PERMIT TO INSTALL PLUMBING

Re: 204-206 Danforth Street
Portland, Maine

Subject: Building permit to cover construction
of wooden fire escape on rear of building
from third floor to ground at 206 Daforth
Street

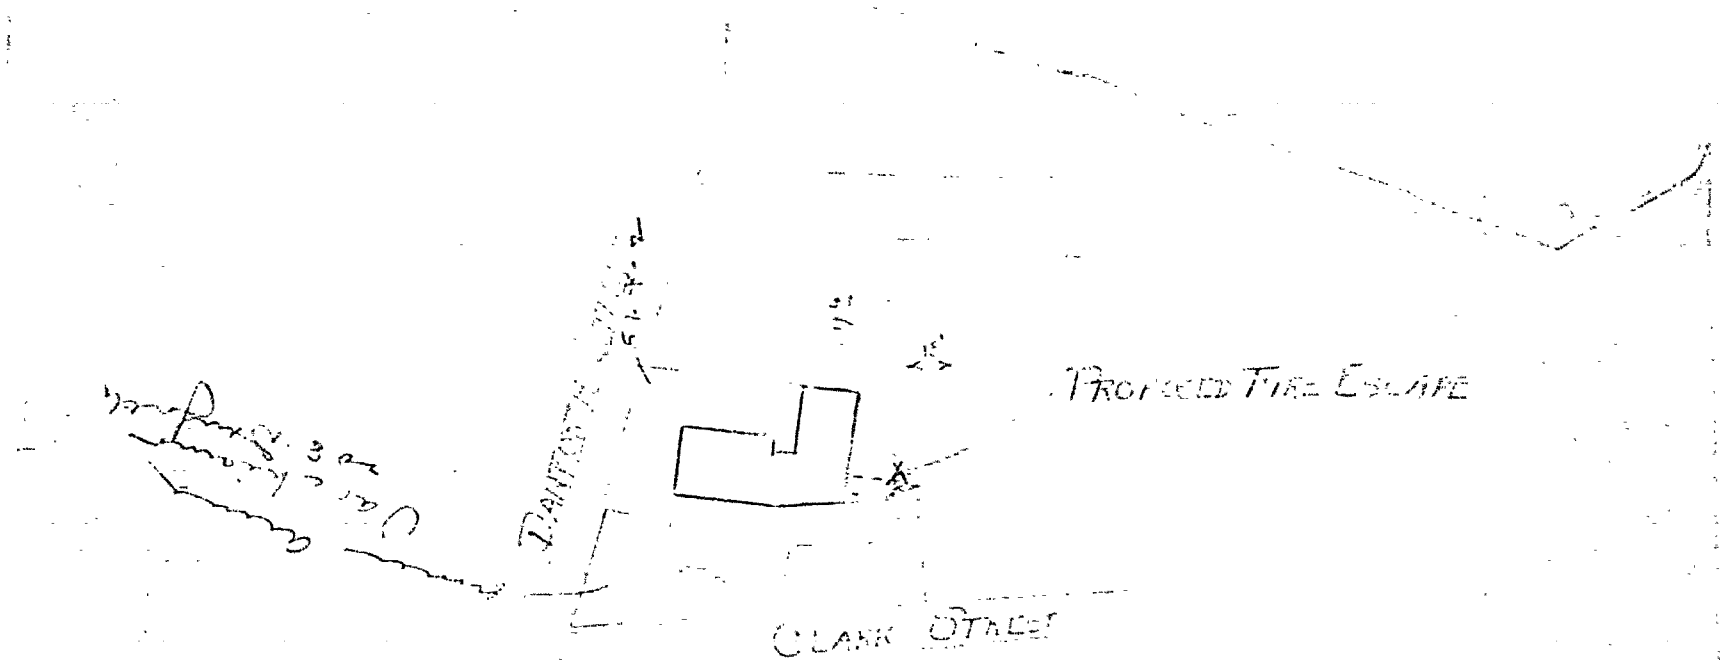
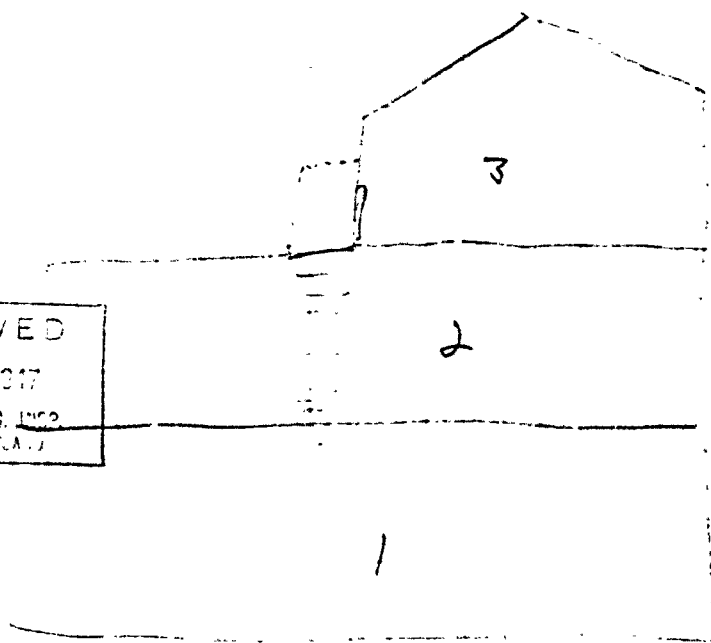
He noted that the foundation beneath the bottom of the lowest run of stairs has not been built according to the plan. The grade of the ground around the pier is higher than the top of the pier so that if the ground is filled in level, the wooden stairway would be surrounded by dirt. The plan shows and you are required to have the pier extending no less than 6" above the finished grade of the ground, and the woodwork of the stairway supported well above the top of the ground on the pier. The plan indicates that the pier is to be made high enough and long enough and wide enough to form the bottom step and at the same time the support for the wooden stringers of the stairs so that they will be well above the ground. This means that the present lower run of stairs (this has already been erected without a permit) are to be adjusted so that the arrangement shown on the plan is accomplished, even though it means removing the entire run and rebuilding them. At the same time care must be exercised that the height of risers and the width of treads of this run of stairs are kept uniform.

All piers are required to extend no less than 4' below the surface of the ground which is the scaled distance shown on the plan.
